# **MEMO**

Review of Water Right Application G-18802

# **Groundwater Application Review Summary Form**

Application # G- 18802	
GW Reviewer Phil Marcy	Date Review Completed: 3/22/2019
Summary of GW Availability and Injury Review:	
[ ] Groundwater for the proposed use is either over amounts requested without injury to prior water rigl capacity of the groundwater resource per Section B	hts, OR will not likely be available within the
Summary of Potential for Substantial Interference F	Review:
[ ] There is the potential for substantial interference	per Section C of the attached review form.
Summary of Well Construction Assessment:	
[] The well does not appear to meet current well coreview form. Route through Well Construction and constru

Construction/lithology diagram for the proposed POA well, displaying continuous case and seal depth of 298' BLS above the productive water-bearing zone in fractured volcanic rock.

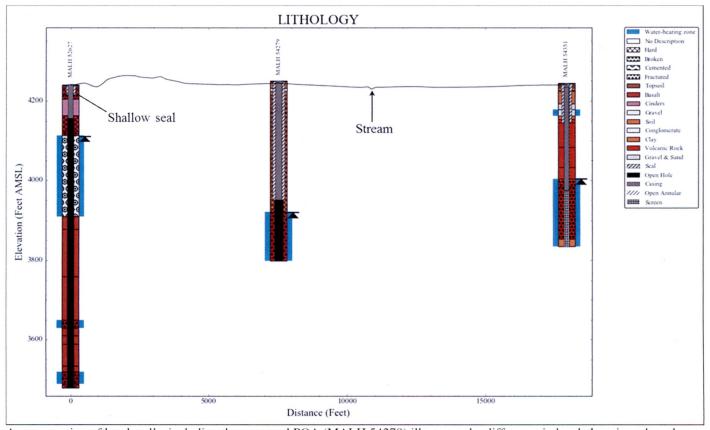
A cross section of local wells, including the proposed POA (MALH 54279) illustrates the difference in head elevations, based upon the water-bearing zones utilized by each well. MALH 52627 produces from gravels between 126'-330' BLS, with a resulting head elevation of 4113' AMSL, whereas MALH 54351 and the proposed POA are constructed to produce solely from fractured volcanic rock at depth and report static elevations of 4003' and 3951' AMSL, respectively.
